SB-929

SERVICE BULLETIN AMATEUR RADIO

SUBJECT TS-140S MOMENTARY TRANSMISSION WHEN VOX IS TURNED ON	DATE 4/11/88
---	-----------------

REFER TO FIGURE ONE FOR THE NEXT TWO STEPS.

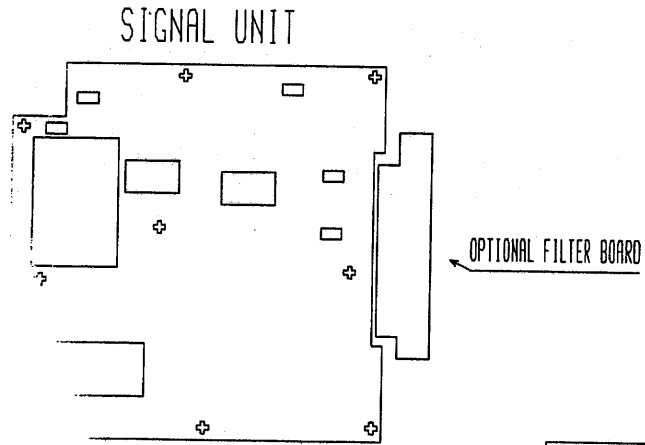
3. Unplug the wires at connectors CN4, CN12, CN18, CN19, and CN20.
4. Remove the nine screws from the signal unit.
5. Slide the Signal unit forward until the external speaker jack clears the back panel cutout.
6. Carefully lift the Signal unit up from the back side and rotate it toward the front panel to expose the bottom of the board.
7. Locate chip capacitor C504 on the bottom of the board (see figure 2). If required, refer to the service manual board diagrams for details.
8. Unsolder and remove C504.
9. Install and solder the .001uF capacitor in place of C504.
10. Assemble the transceiver by reversing the above steps.

FIGURE 2

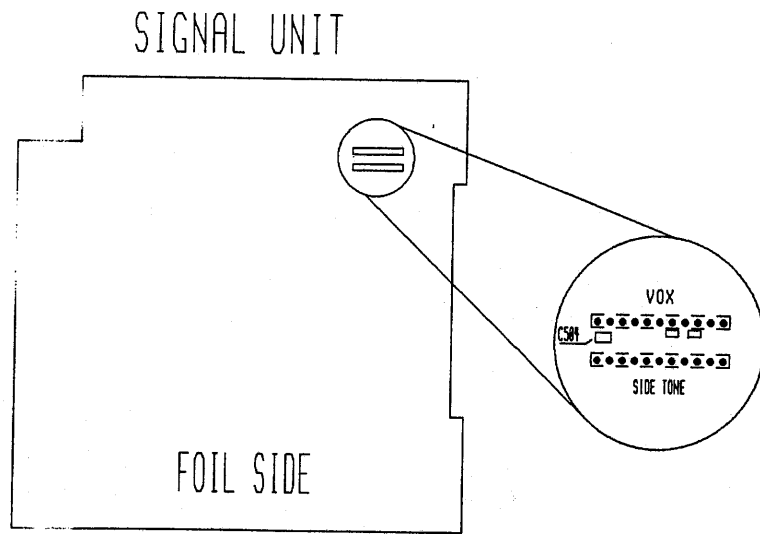
When the VOX switch is turned on immediately after the power switch is depressed, the TS-140S may trip into the transmit mode. This condition can be corrected by changing the value of chip capacitor C504 on the Signal unit. The following procedure will detail how to access the capacitor.

C504 0.001uF, 50V chip capacitor. KENWOOD PART # CK73FB1H102K
